VILLAGE OF WEST LAFAYETTE
COSHOCTON COUNTY, OHIO

WWTP OUTFALL & STORM SEWER OUTFALL IMPROVEMENTS

ADDENDUM #1

AUGUST 22, 2023

PHASE No.	WEST LAFAYETTE WWTP OUTFALL AND STORM SEWER OUTFALL IMPROVEMENTS	SHEET No.	20
CONTRACT No.			
PROJECT No.	020-10127		
PLAN & PROFILE SAN 520+00-525+50

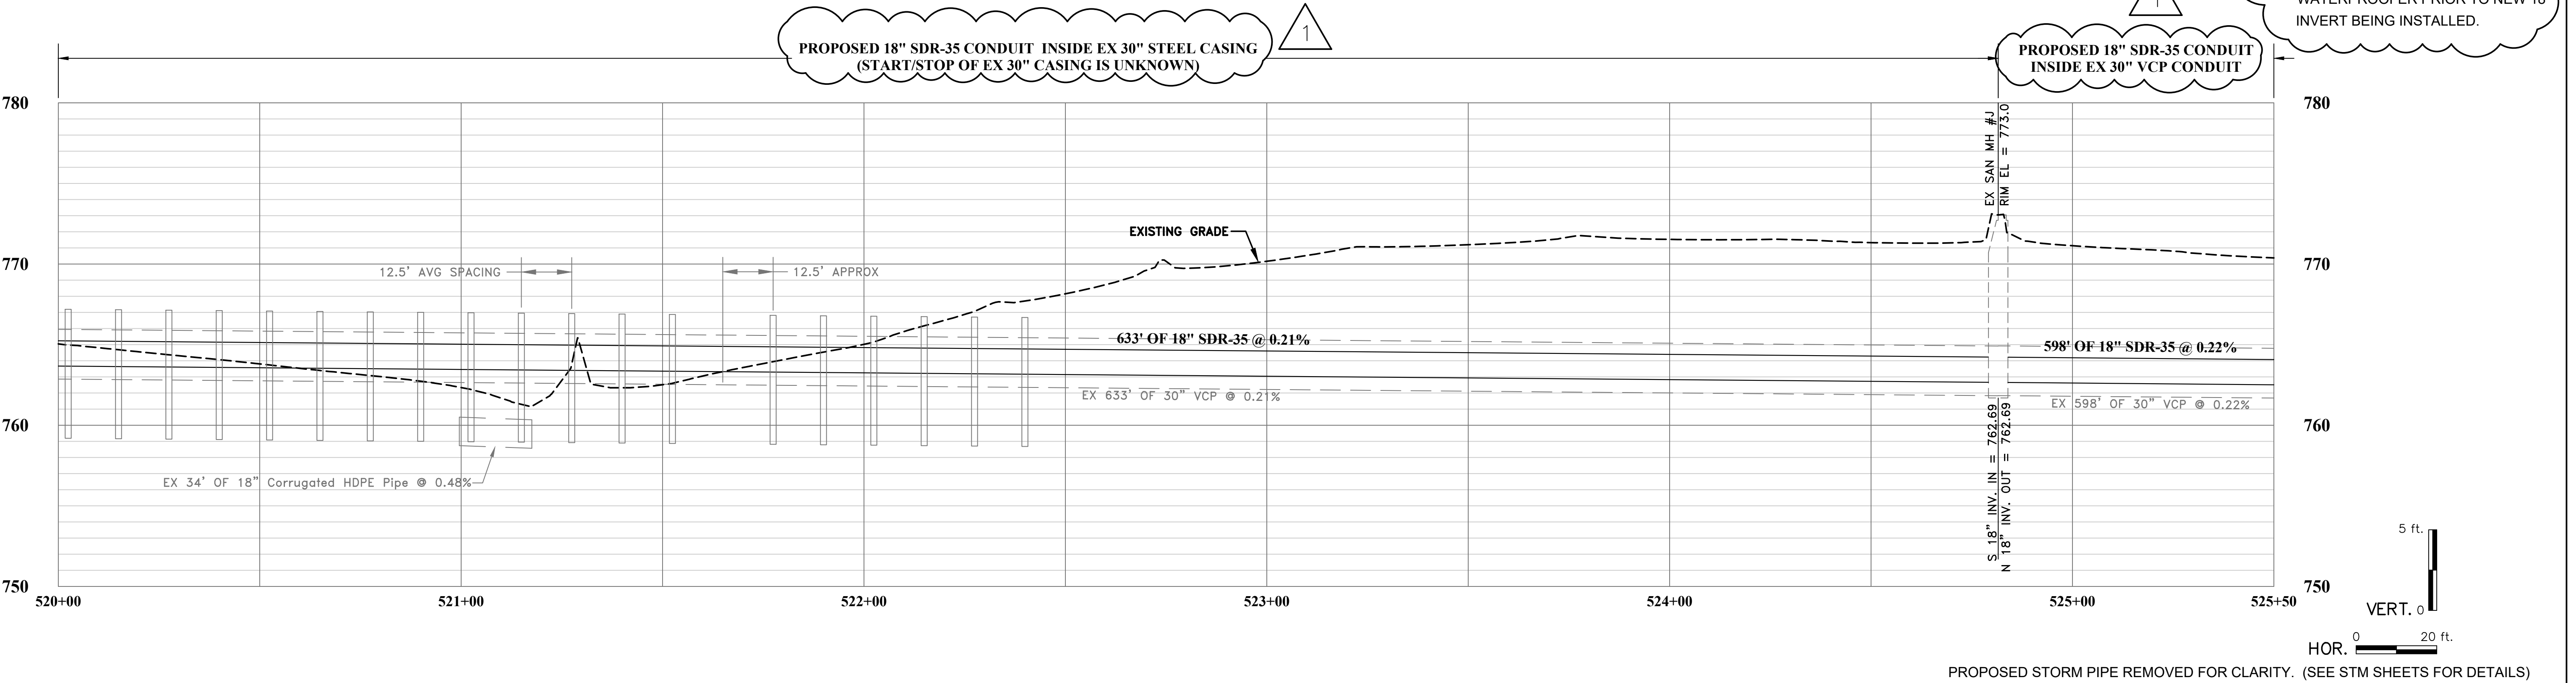
THE INFORMATION CONTAINED HEREIN IS THE SOLE PROPERTY OF THE THRASHER GROUP INC. REPRODUCTION OF THESE DOCUMENTS IN WHOLE OR IN PART, FOR ANY REASON WITHOUT PRIOR WRITTEN PERMISSION, IS STRICTLY PROHIBITED. COPYRIGHT © 2021 THE THRASHER GROUP INC.			
NO.	BY	DATE	DESCRIPTION
1	AMF	21AUG2023	CORRECTED STEEL PIPE SIZE

PHASE No.	WEST LAFAYETTE WWTP OUTFALL AND STORM SEWER OUTFALL IMPROVEMENTS	SHEET No.	27
CONTRACT No.			
PROJECT No.	020-10127		
GENERAL DETAILS

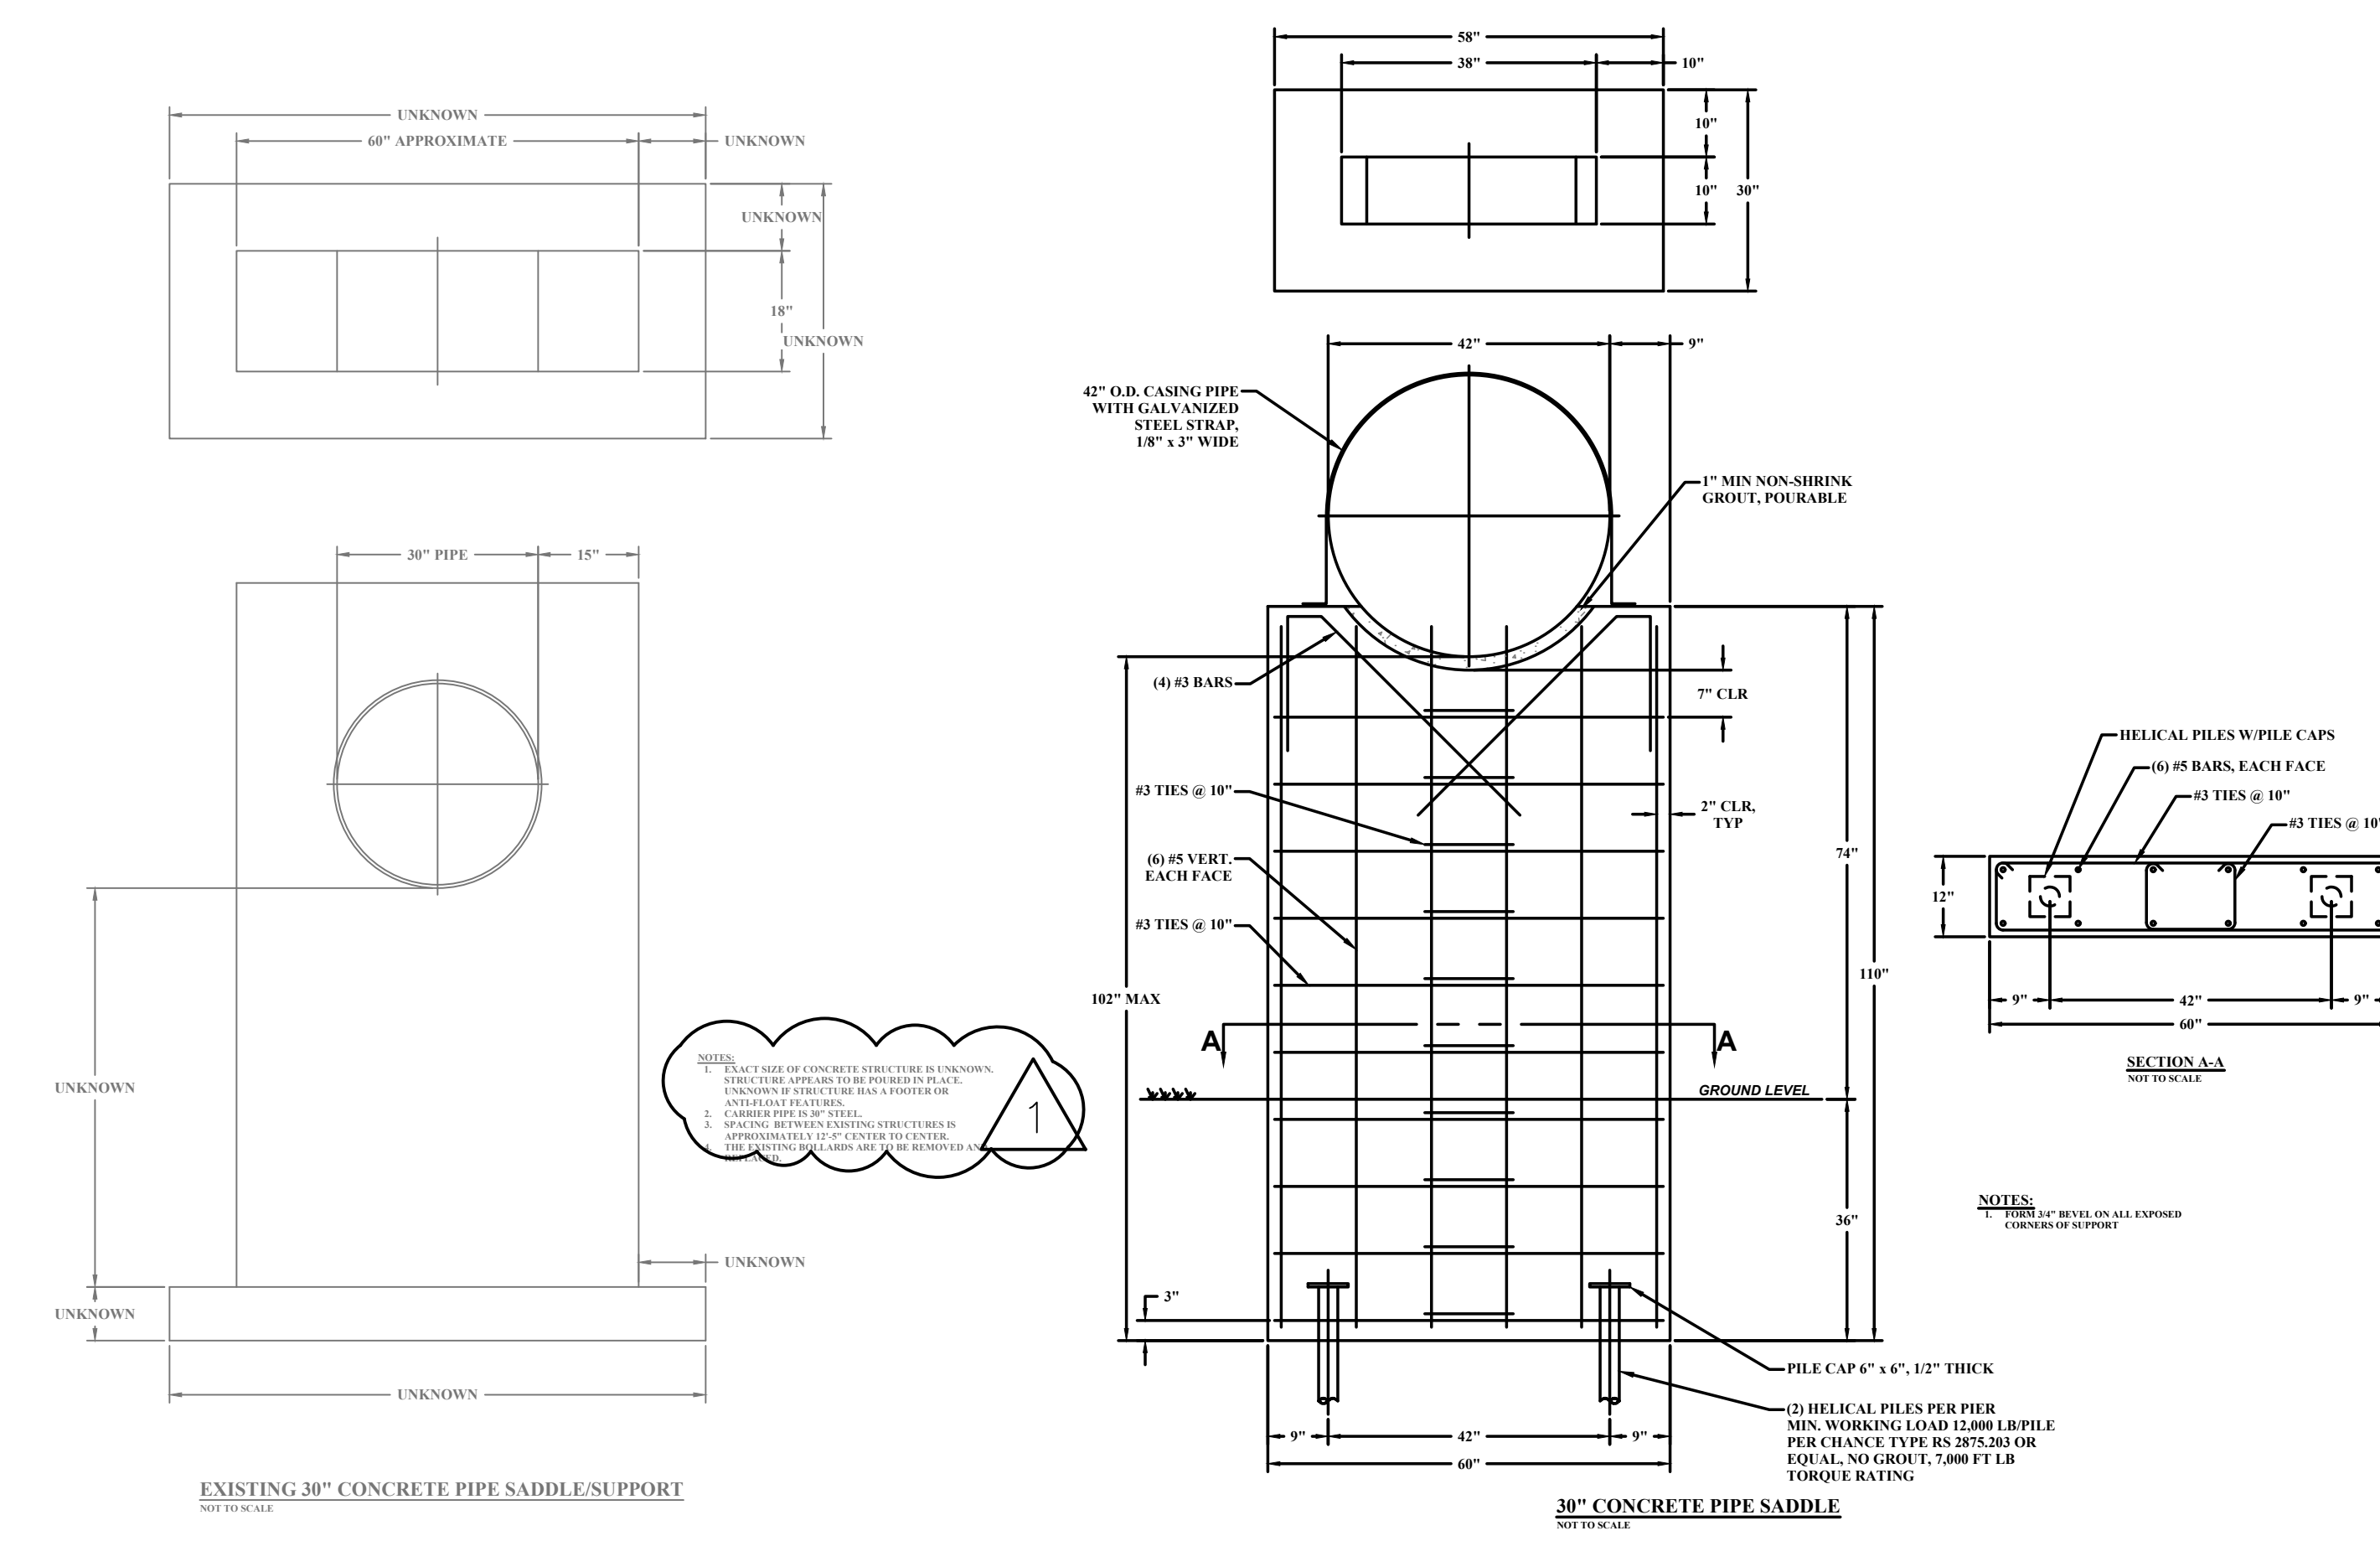
1. Is the detail on page 27 used only on the pile pointed to on sheet 18?

The detail on page 27 is used for all piles in the project. There are a total of 58 piers with 2 Helical piles per pier.
